Rosemount District Centre  
Enhancement Programme

South Dublin County Council

Public Consultation Summary

6 November 2023

#### **Traffic Calming Concerns.**

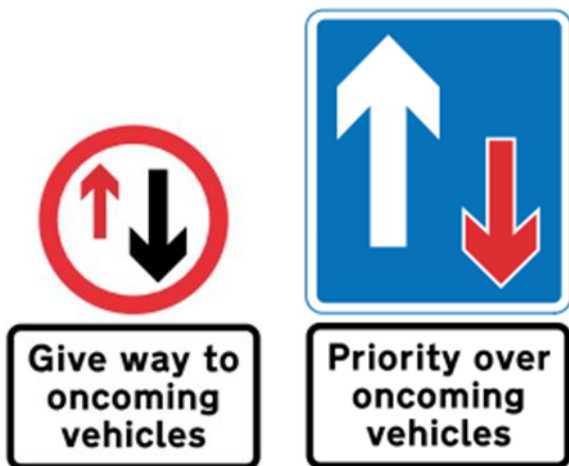
Concerns regarding the installation of traffic calming measures on Marian Rd and whether this will affect residents exiting their driveways and increase in traffic volume. Comments of the style of traffic calming measures being implemented were also noted as a concern. There were 26 comments relating to this which is around 23% of all comments received.

No change recommended.

### Option 2 - RSA Stage 1 - Auditors Recommendation

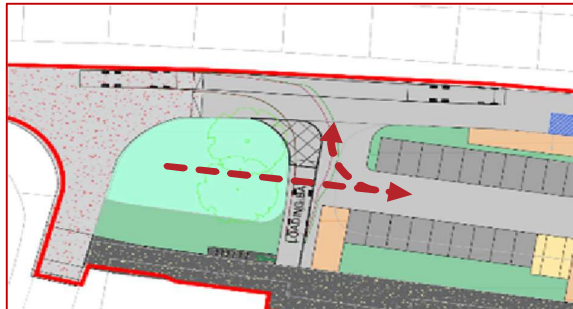
Auditors Recommendation suggested –

*“Should swept paths permit it, the loading bay should be relocated into the adjacent grassed area where reversing onto Marian Road is not required. It would be preferable for delivery vehicles to reverse within the car park carriageway and exit the car park facing forwards.”*

As shown, this option would require two existing trees to be felled to accommodate the relocated loading bay. Additionally, the loading vehicle would not be able to continue north on Marian Road from exiting the loading bay as geometry would be too tight. The loading bay could be provided further south to widen the exiting angle, however, this would require further removal of existing green space.
